**Re: 1401-03 SW Winthrop Ter. - Framing Evaluation Report**  
**Lee's Summit, MO**  
**Bldg. Permit No.: PRRES20245644**

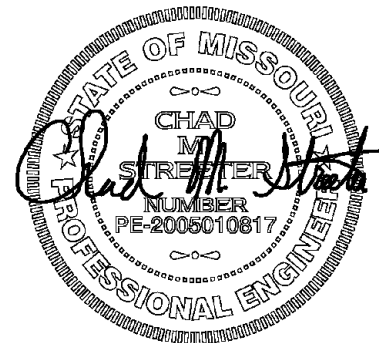
This letter is in regard to our evaluation of the ridge splice for the above mentioned duplex. During our initial inspection, we had noted that the ridge was not continuous and had been spliced. We had recommended that a second 2x8 be sistered to the ridge and extend beyond the splice on each end a minimum of two feet.

Once the recommended repair had been completed, we had noted that the sistered 2x8 had been installed in accordance with our initial recommendation. Based on our evaluation, the ridge is adequately tied together and no further corrective action is required.
